VERTICAL DRIVE SHAFTS
AND ASSOCIATED APPARATUS

1.01 This addendum covers revisions in the requirements covering Location and Alignment of Shafts and Bearings, Starting Torque Test and Mounting of Eccentric Coupling Guard. It also covers changes in the adjusting procedures for Location and Alignment of Shafts and Bearings and Mounting of Eccentric Coupling Guard. It supplements Section A401.701, Issue 3-D and replaces Issue 3-D of the addendum to this section. This addendum is reissued to cover revisions in the requirements covering Location and Alignment of Shafts and Bearings (2.06) and Starting Torque Test (2.11). Detailed reasons for reissue will be found at the end of the parts affected.

2.001 The following requirements replace requirements 2.06, 2.11 and 2.18 of Section A401.701, Issue 3-D.

Fig. 1

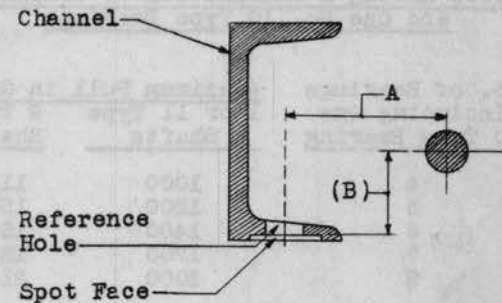
(1) Fig. 1 (A) - The perpendicular distance between the centerline of the vertical drive shaft and the centerline of the reference hole is $2-11/64" \pm 1/32"$.

(2) Fig. 1 (B) - The perpendicular distance between the spot face of the channel and the centerline of the vertical drive shaft is $1-1/4" \pm 1/32"$ measured at a point just beneath the bearings.

Fig. 2

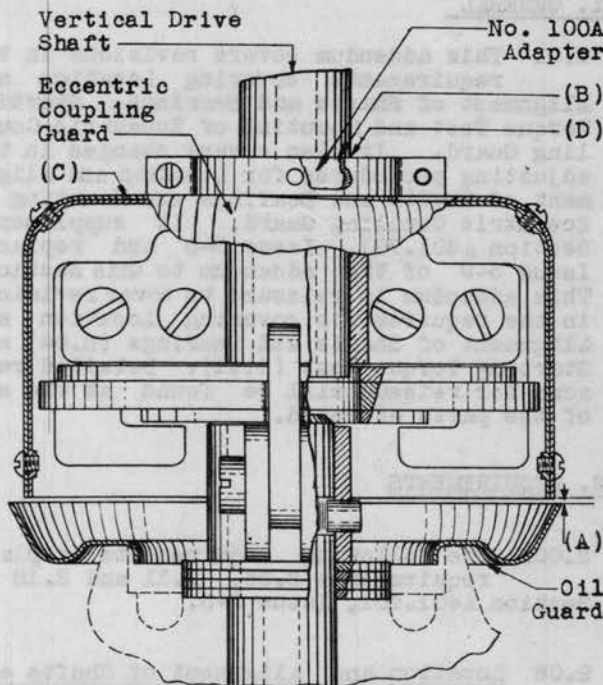
(a) Fig. 2 (A) - The vertical clearance between the bottom edge of the eccentric coupling guard and the upper edge of the oil guard shall be $1/16"$ $\pm$ $1/64"$. Gauge by eye.

(b) Fig. 2 (B) - The upper surface of the eccentric coupling guard collar shall be approximately flush with the upper surface of the associated No. 100A adapter unless the adapter mounts directly against the No. 5A drive hub in which case the coupling guard collar may extend up above the adapter. Gauge by eye.

(1) Fig. 2 (C) - The joints where the eccentric coupling guard halves overlap.

- (2) Fig. 2 (D) - The joints between the eccentric coupling guard collar and the No. 100A adapter (where used) and the slots in the collar.
- (3) The slots in the No. 100A adapter and the joint between the adapter and the shaft.
- (4) Fig. 3 (B) - The joints between the eccentric coupling guard collar and the No. 5A drive (where used to mount the coupling guard) and the slot in the collar.
- (5) Fig. 3 (C) - The joint between the No. 5A drive and the shaft.

Fig. 3

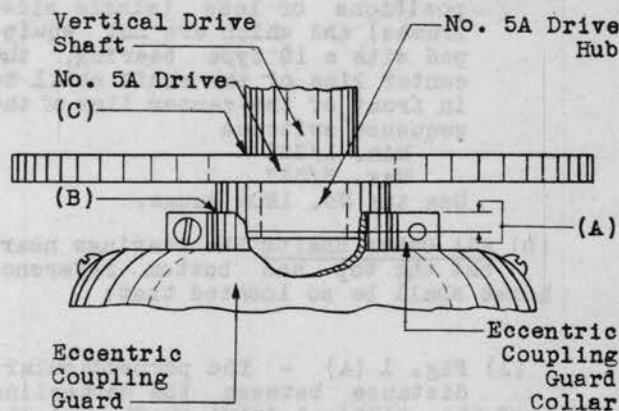
(c) Fig. 3 (A) - When the eccentric coupling guard mounts on a No. 5A drive hub it shall overlap the straight sides of the hub by approximately $5/32"$ except in cases where the No. 100A adapter is mounted directly against it. Gauge by eye.

Fig. 5 - Gauging Limit When Checking Short Shafts

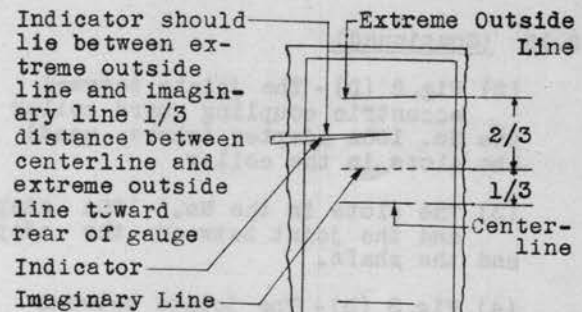
(3) When checking vertical drive shafts (short shafts) associated with 15 sequence switch positions or less and not equipped with 10 type bearings, note that the gauge reading as shown in Fig. 5 indicates that the center line of the shaft is in front of the center line of the sequence switches. The shaft is so positioned in order to reduce the possibility of the drive shaft climbing when a number of associated sequence switches are operated simultaneously. In the case of the longer shafts this is not necessary because the weight of the shaft tends to prevent its upward movement.

Fig. 4 - Method of Checking Alignment of Bearings

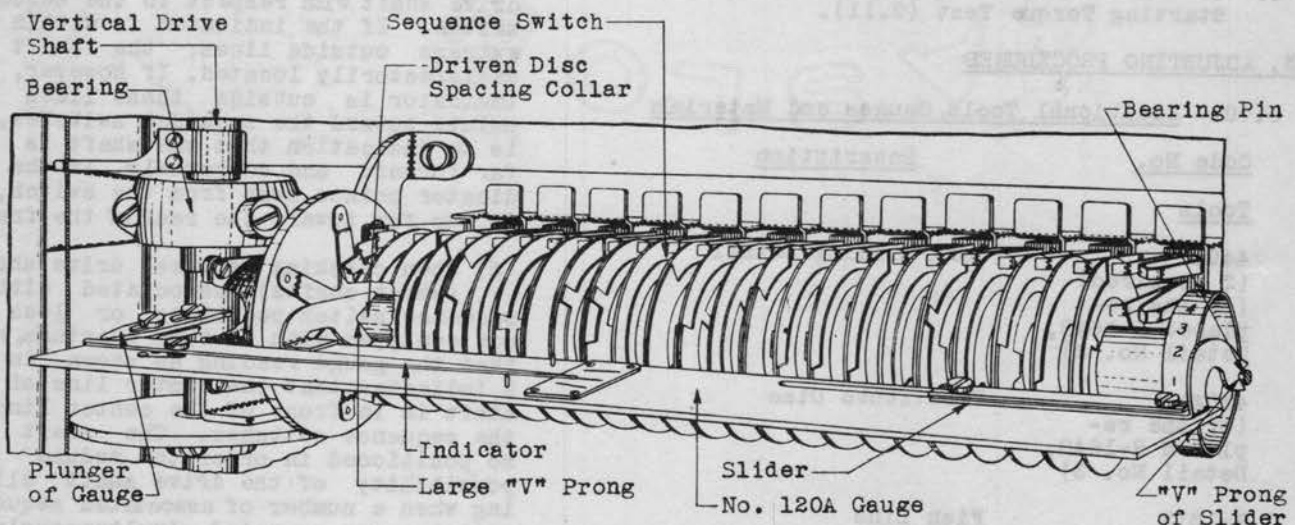
(5) Before realigning a shaft, note whether the misalignment is in one direction. Also, note whether that portion of the shaft which is satisfactorily aligned, leans in the same direction as that portion of the shafts which is not within limits. In this case, determine the best average adjustment within limits and readjust the shaft to this average position as follows. Place the No. 120A gauge against the sequence

Fig. 6 - Method of Checking for Location of Bearings

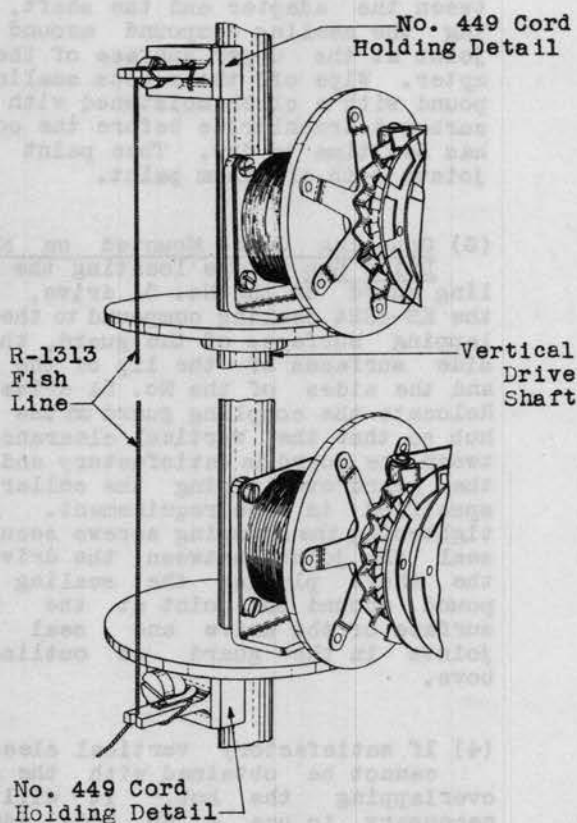
(7) Attach the two No. 449A cord holding details to the shaft, one detail above or at the top bearing and one at the bottom end of the vertical drive shaft. Stretch the R-1313 fish line tightly between the two supports as shown in Fig. 6. The fish line will then be parallel to the shaft.
